Addressing Clause 185 comments against D1.3 for 800GBASE-LR1

(Support contribution for Comments #474, 475)

P802.3dj Interim Meeting, Phoenix, USA, Jan 2025

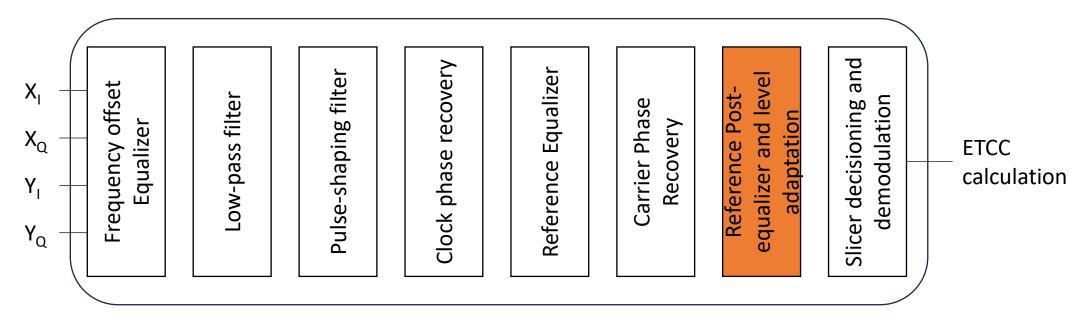
The offline digital signal processing described in this section is missing a post-equalizer after the "carrier phase recovery" block which is required to allow relaxation of the TX I-Q skew to the 0.75ps spec in Table 185-5.

- Table 185-5 includes a "I-Q quadrature skew (max)" specification of 0.75ps
 - This specification corresponds to 0.093UI normalized to the symbol period of 800GBASE-LR1
 - Specifications from prior generation coherent interfaces such as the OIF 400ZR IA had a tighter requirement of 0.045UI.
 - The relaxation envisioned by this specification requires the use of a post-equalizer after carrier recovery and this block is required in the reference DSP processing described in Section 185A.2.3 and shown in Fig 185A-4. See kota 3dj 02 2407 Slide 14 for an example.

Add post-equalizer stage to the digital signal processing. Presentation to be provided.

Add a post-equalizer stage to Fig 185A-4.
